Technical Service Information Bulletin

GLOVE BOX RATTLE

'04 RX 330

NVH
NV012-03

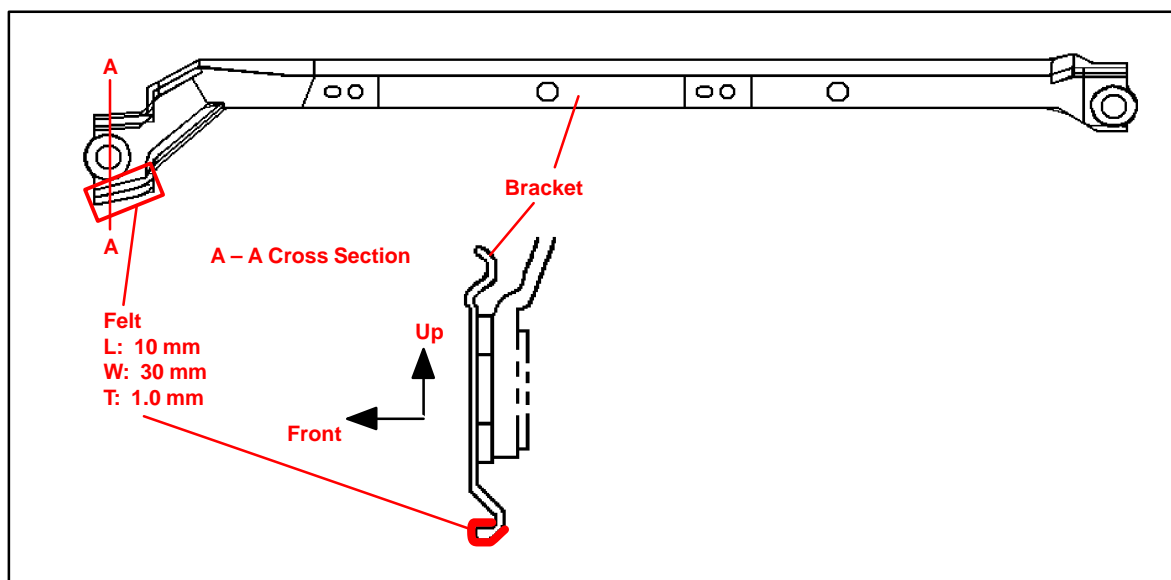
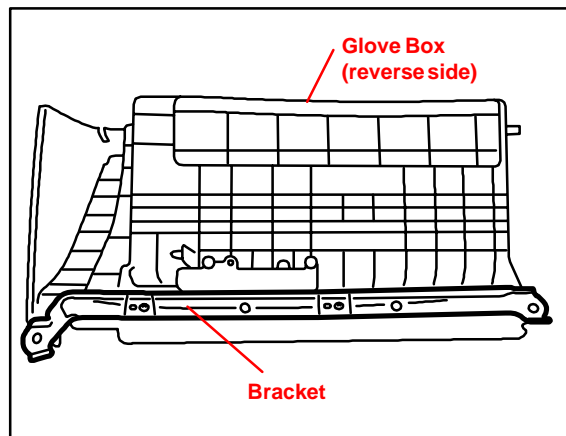
Introduction Some customers may experience a rattle from the bracket of the glove box area. The following procedure has been developed to reduce the noise.

2. Fit a felt piece to the bracket of the glove box as shown below.
